**CONTINENTAL MOTORS® AIRCRAFT ENGINE  
CRITICAL SERVICE BULLETIN**

**CATEGORY 2  
CSB15-2C**

**Supersedes CSB15-2B  
TECHNICAL PORTIONS  
FAA APPROVED**

- SUBJECT:** Oil Cooler Cross Fitting Replacement
- PURPOSE:** To replace oil cooler cross fitting (part numbers AN918-1J and AN918-2J) with a new enhanced cross fitting (P/N 658607).
- COMPLIANCE:** Within the next 25 hours of engine operation or the next scheduled inspection or engine servicing, whichever occurs first.

Figure 1. Cross Fitting Stack-Up, Prior Configurations

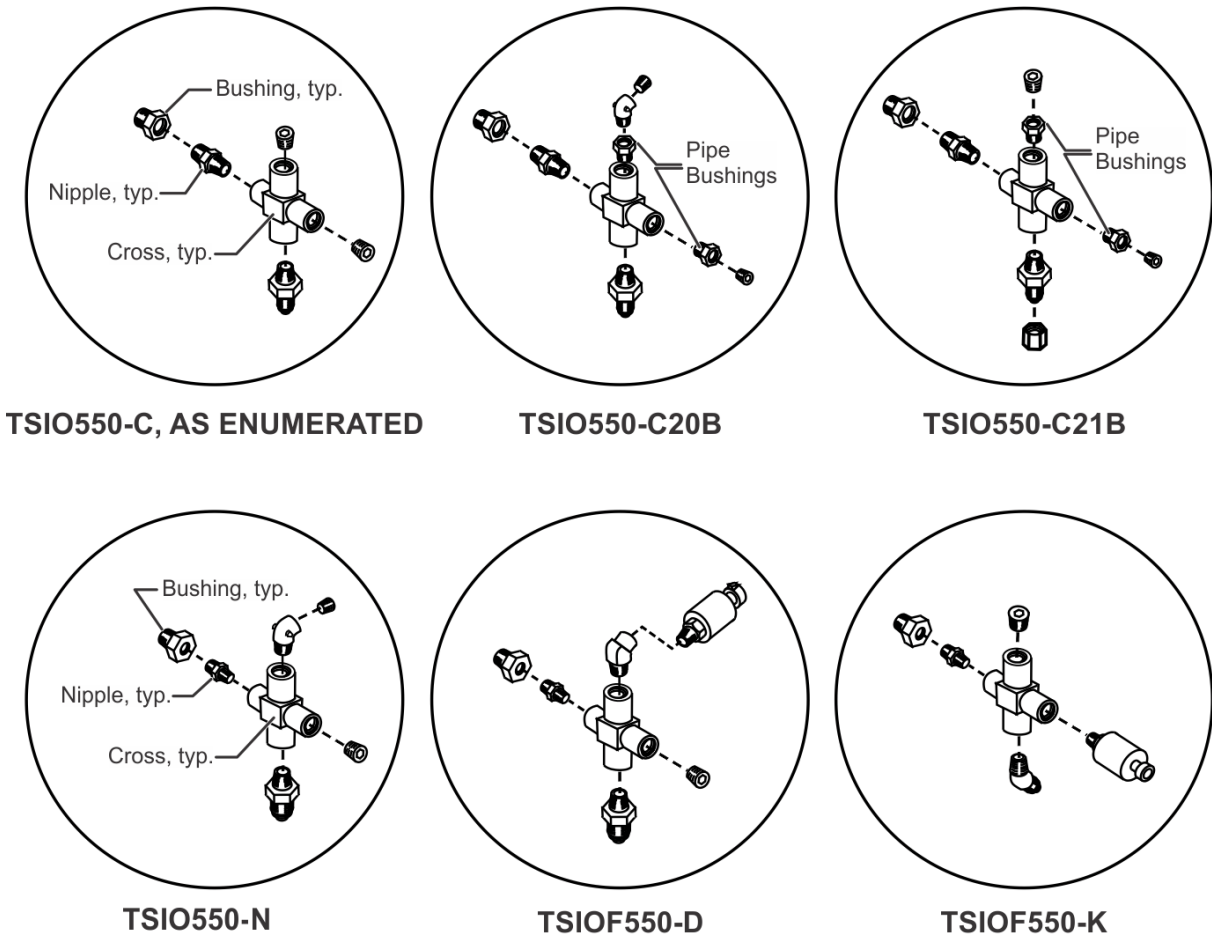
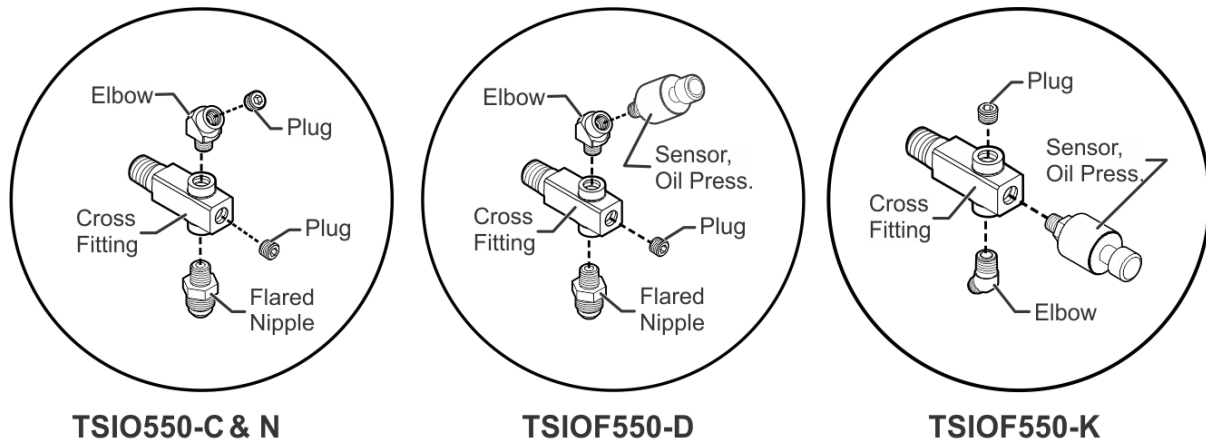
1. Eliminate the pipe bushing and nipple fitting stack-up (see Figure 1) typically found between the cross fitting and the oil cooler and replaces them with a single cross fitting (P/N 658607).

4. Remove the additional pipe bushings (P/N AS4861J01) used for the oil pressure sensor and pipe plug previously installed on TSIO550-C20B and -C21B installations (see Figure 1). These bushings are obsolete (for this application) and will no longer be necessary for the new cross fitting installation; the AN915-1J 45-degree elbow fitting or pipe plugs fit directly into the new cross fitting (see Figure 2).

Figure 2. Cross Fitting, NEW Configurations

Figure 3. Cross Fitting, Comparison

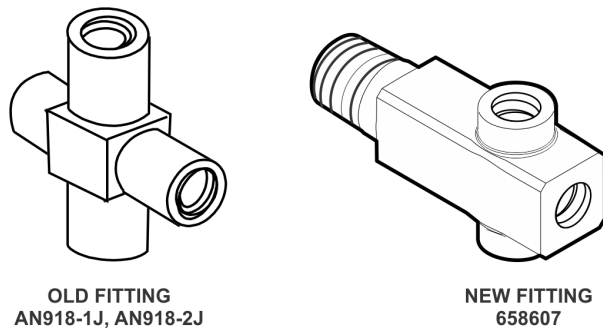
REMOVE AND REPLACE the superseded parts with new cross fitting (P/N 658607) using the same procedures located in your M-18 or M-26 Maintenance and Overhaul Manuals. Reference the latest revision of the CMI Illustrated Parts Catalog (IPC) to determine applicable additional connectors, elbows, or plug part numbers and adjust the instructions accordingly.

**Figure 4. Hose and Tube Installation Support**

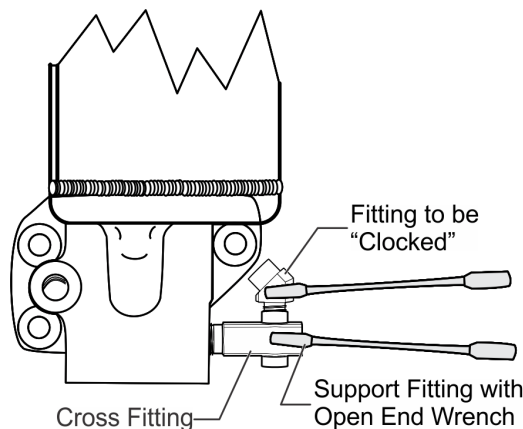
- b. Support the last fitting in the assembly on components that contain multiple fittings coupled in one location (see Figure 4). DO NOT over-torque fittings.
